## Golf Team,

I have see a few different solar panel illustrations. However this one from KF4KSS Symposium 2018 shows this;

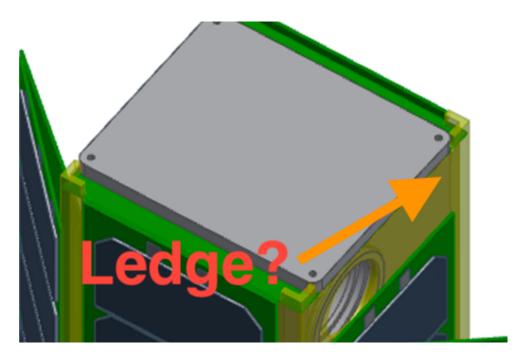
#1 - Is a solar panel indeed behind the main panel? This is important because I must consider the amount of room I have during the stowed position. The CalPoly only allows 6.5mm protrusion beyond the surface of the rail.

#2 - In some illustrations it looks like there is a thickness between the rails and the body of the golf? If this area exists it give room below the rail surface, so I'll need to know the thickness of the corner stock as shown here.

#3 - The inventor files I have found for the GOLF-ASSEMBLY show a rectangle housing with the edges cut off, I have not found a resource in CAD that shows the rails and how the illustration below fastens in.

Figure 5 Square Aluminum Tube of GOLF

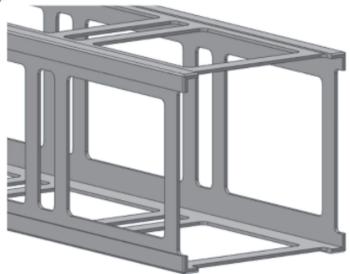
## #4 - Do we know where the CAD file is for the extruded Aluminum Tube

GOLF cross-section is made from thin-walled square aluminum extrusion. This will be cheaper and easier to implement. It's heavier than thinner sheetmetal, but Foxes ended up using lead ballast to approach their mass of 1.33 kg.
